Loss of throttle actuation in trucks with EDC, CAG and Scania retarder

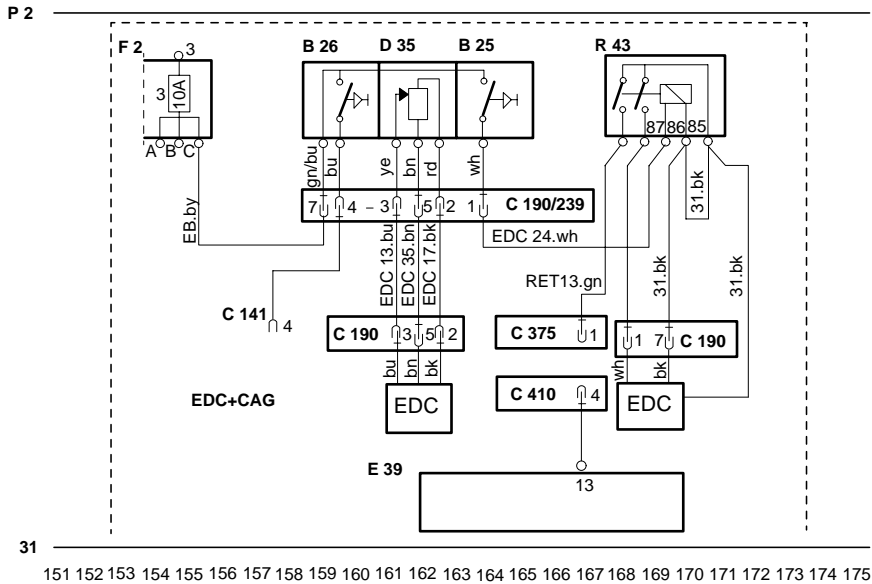
This problem is caused by the interaction between the throttle pedal sensor, part number 1 308 297, and relay R43, part number 326 320.

In order to remedy this problem, relay R43 should be replaced with a diode unit. The throttle pedal sensor must be changed at the same time.

4. Remove relay R43 from its relay holder.
5. Do the following the relay holder where the diode unit will be located:
 - Switch cables RET13.gn (previously R4387B) and EDC 24.wh (previously R43-86) with each other.

- Cable EDC24.wh (previously R43-87) is left in place.
 - Detach and insulate both twin-strand cables 31.bk (previously R43-30 and R43-85). These must not be cut off.

- **Note:** As there are two white cables are marked EDC24, it is important to move the correct one.
6. Fit diode unit D46 in the relay holder.
7. Fit a new relay, R43, part number 243 460, and a new relay holder in the central electric unit.

8. Fit a new cable between fuse 3 (pin C) in fuse holder F2 and R43-30. Detach and insulate the existing cable.
9. Fit a new cable between R43-30 and R43-86.

10. Cut the cable between C190/239-4 and C141-4. Connect cable C190/239-4 to R43-85 and cable C141-4 to R43-87.
11. Cut off cable EB.bu from connector C190/239-7 and connect it to cable 31.bk from C190-7. Note that there are three cables to this terminal.
